Our ref: Bridgewater Bridge Refurbishment
Enquiries Lyndal Byrne, Senior Strategic Planner
Direct phone: (03) 6216 6424
Email: Lyndal.Byrne@gcc.tas.gov.au

**BRIDGEWATER BRIDGE MAJOR PROJECT — COMMENTS ON ASSESSMENT CRITERIA,
MAJOR PROJECT IMPACT STATEMENT AND INITIAL ASSESSMENT REPORT**

Design Drawing No 1401**Heritage**

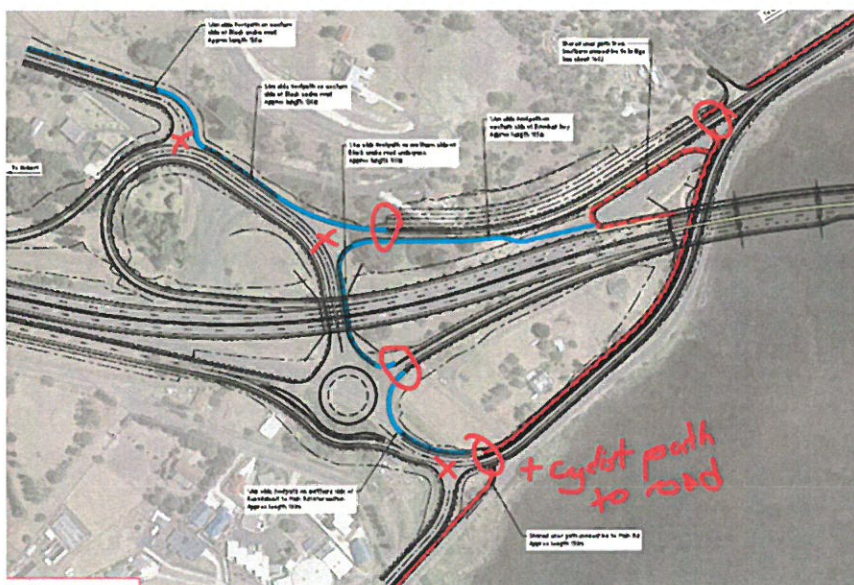
The TIA models the traffic flow in detail but lacks information on pedestrian and cycling connections (circled in red in the image below Design Drawing No 1401) and the minor intersections (red crosses on image), in particular:

- The shared use path / footpath requires users to cross the road at two points, one on the Lyell Highway and one on Main Road. The TIA should address how this can be achieved safely in regard to sight distances, traffic volumes, gaps in traffic and waiting times.
- Cyclists using the shared use path on the bridge may wish to transition to the road onto the Lyell Highway or Main Road. The TIA should address where and how this will occur safely and how they will be catered for at the southern roundabout.
- The minor intersections will generate considerable traffic with little details on any treatments required at these intersections at Black Snack Road, Main Road and onto Lyell Highway. The TIA should address the volume, delays and any treatments such as right turn lanes, at these minor intersections.

It is therefore requested that the chosen design is assessed in respect to the above matters.
